Access Compliance Report

Public Rights-of-Way

Intersection ID: 49252	Main Street: ROCKLAND_DR	Cross Street: BROOKE_NICOLE_PL	Location: S
ADA ID: 9E7455C3BC37	Ramp Type: PerpDiag	Initial Pass/Fail: Pass	Overall Compliance: No
Severity Score: 5.25			
Codes/Mitigation Info/Possible Solution		Field Measurements/Component Compliance

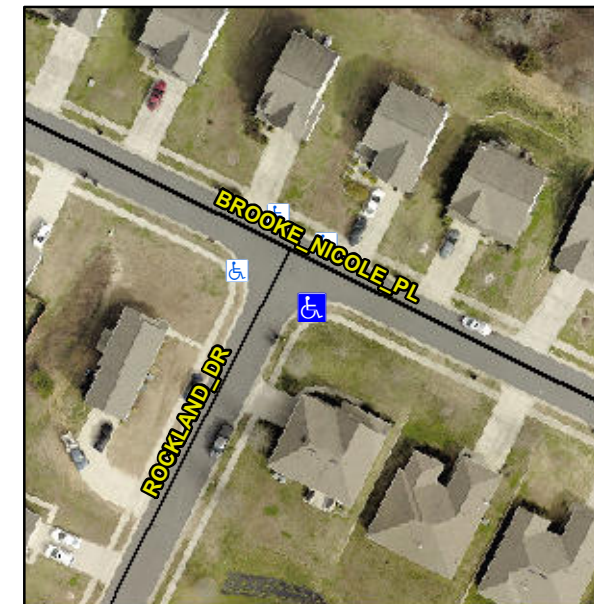
Not Found, R304.5.3, R305.2, R304.5.4

Compliance	Description	Data	Compliance	Description	Data
N/A	Ramp Length (in)	48.0	Yes	Ramp Slope (%)	5.1
Yes	Ramp Width (in)	48.0	No	Ramp XSlope (%)	4.0
N/A	Flare Type LT	Sloped	N/A	Flare Type RT	N/A
N/A	Flare Slope LT (%)	7.0	N/A	Flare Slope RT (%)	4.4
N/A	Flare Traversable LT?	No	N/A	Flare Traversable RT?	No
Yes	Landing Length (in)	48.0	Yes	DWS Provided?	Yes
Yes	Landing Width (in)	77.0	Yes	DWS Contrast?	Yes
Yes	Landing Slope (%)	0.9	Yes	DWS Length (in)	24.5
No	Landing X Slope (%)	5.6	Yes	DWS Full Width?	Yes
N/A	Landing Curb? (Y/N)	No	No	DWS Offset (in)	3.0
N/A	Shared Landing?	No			
Yes	Gutter Ponding?	No	No	Gutter Slope (%)	7.8
Yes	Gutter Lip Ht (in)	0.0	No	Gutter X Slope (%)	2.1
N/A	Painted X Walk1?	No	N/A	Painted X Walk2?	No
	X Walk 1 Direction	To E		X Walk 2 Direction	To W
N/A	X Walk 1 Width (in)	N/A	N/A	X Walk 2 Width (in)	N/A
	X Walk 1 Slope (%)	3.6		X Walk 2 Slope (%)	5.4
	X Walk 1 X Slope (%)	10.3		X Walk 2 X Slope (%)	5.1

N/A	Ramp inside XWalk1?	N/A	N/A	Ramp inside XWalk2?	N/A
	Road Slope (%)	2.4	N/A	Clear Space?	Yes
	Road X Slope (%)	7.5	N/A	Clear Space to XWalk (in)	N/A
Yes	Any Obstructions?	No	Yes	Storm Grate/Utility Hazard?	No
	Obstruction Type			Storm Grate/Utility Type	
		N/A			N/A
		Yes	Yes	Surface Condition? (G/P)	Good

Remove & Replace Curb Ramp With Two New Directional Ramps or Equivalent. Remove & Replace Gutter.
